**COLE'S PLACE SUBDIVISION, UNIT THREE,**  
**RESUBDIVISION OF LOTS 5 & 6**

APPLICATION NUMBER 5 DATE April 7, 2016  
APPLICANT Cole's Place Subdivision, Unit Three, Resubdivision of Lots 5 & 6  
REQUEST Subdivision

# DETAIL SITE PLAN

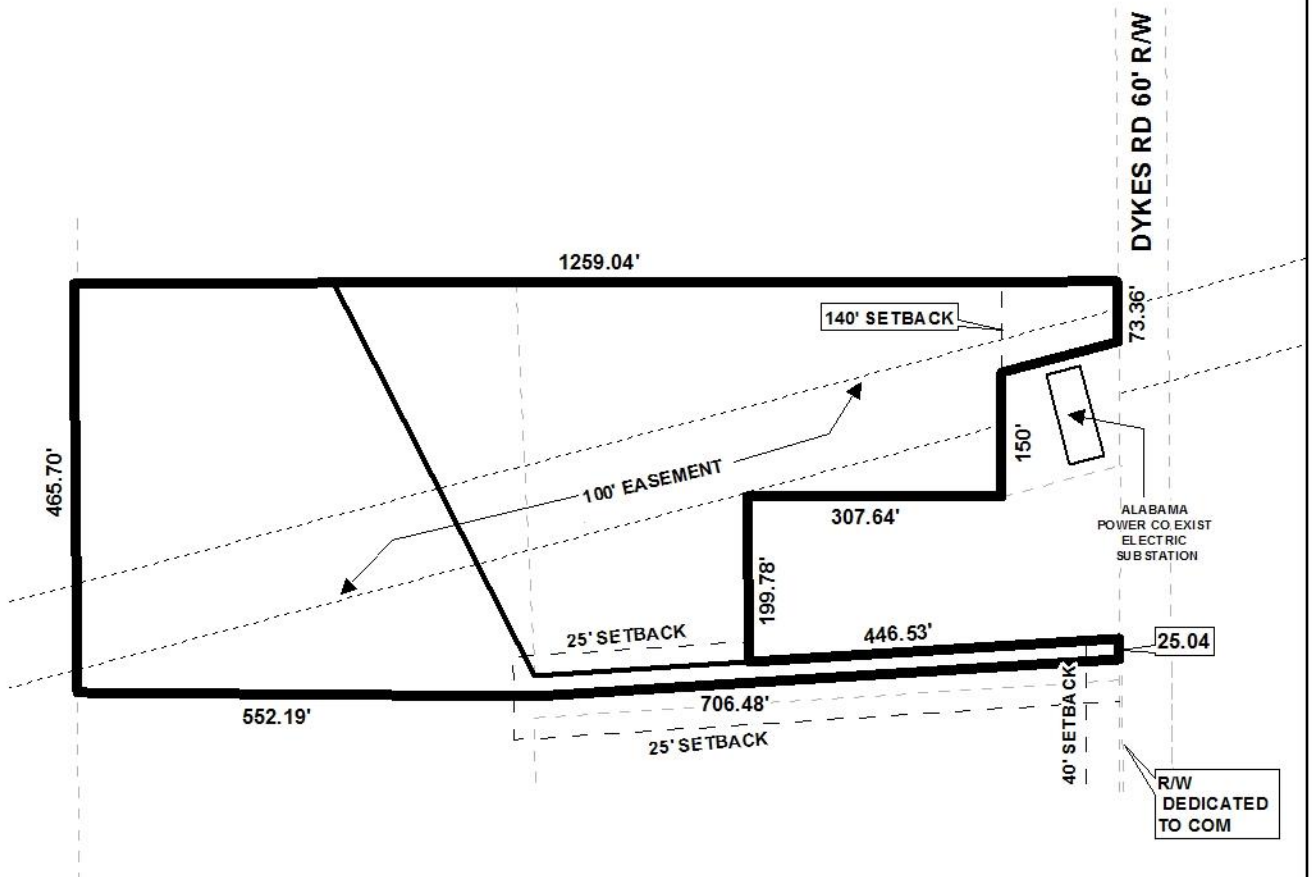
Both lots are labeled with their sizes in both square feet and acres on the preliminary plat and the labels should be retained on the Final Plat, or a table should be furnished on the Final Plat providing the same information.

Access management is a concern due to the limited road frontage width of both lots. The plat has an erroneous note stating that Lot 6 is limited to one curb cut to Dykes Road North. This should be revised to state that Lot A is limited to one curb cut to Dykes Road North, with the size, design and location of all curb-cuts to be approved by Mobile County Engineering and comply with AASHTO standards. A note should also be required on the Final Plat stating that

Lot B is limited to one shared curb cut to Dykes Road North with Lot 4, Cole's Place Subdivision, Unit Three, with the size, design and location of all curb-cuts to be approved by Mobile County Engineering and comply with AASHTO standards.

Lot 5 was originally recorded with a 40' minimum building setback line off Dykes Road North and such is proposed for the Resubdivision, and Lot 6 was recorded with a 140' minimum building setback line off Dykes Road North and such is still proposed. Therefore, the existing building setback lines for Lots 5 & 6 should be retained for Lots A and B on the Final Plat. As on the recorded plat for Unit Three, the preliminary plat indicates a 25' minimum building setback line for both lots from the "pole" for Lot B and this should be retained on the Final Plat.

A 100' wide Alabama Power easement crosses the property, constraining how the property can be developed; thus, a note should be placed on the Final Plat stating that no structures may be constructed or placed within this easement.

Due to the limited access, a note should be placed on the Final Plat stating that no future resubdivision is allowed until adequate frontage on a County-maintained public right-of-way or compliant private street is provided.

- 1) retention of the lot size labels in both square feet and acres on the Final Plat, or the furnishing of a table on the Final Plat providing the same information;

- 2) placement of a note on the Final Plat stating that Lot A is limited to one curb cut to Dykes Road North, with the size, location and design to be approved by Mobile County Engineering and conform to AASHTO standards;

- 3) placement of a note on the Final Plat stating that Lot B is limited to one shared curb cut to Dykes Road North with Lot 4, Cole's Place Subdivision, Unit Three, with the size, location and design to be approved by Mobile County Engineering and conform to AASHTO standards;

- 4) retention of the 140' minimum building setback line for Lot A and the 40' minimum building setback line for Lot B, both along Dykes Road North;
- 5) retention of the 25' minimum building setback line for both lots along the "pole" for Lot B;

- 7) placement of a note on the Final Plat stating that no structures may be constructed or placed within the 100' Alabama Power Company easement;
- 8) placement of a note on the Final Plat stating that no future resubdivision for either lot is allowed until adequate frontage on a County-maintained public right-of-way or compliant private street is provided;
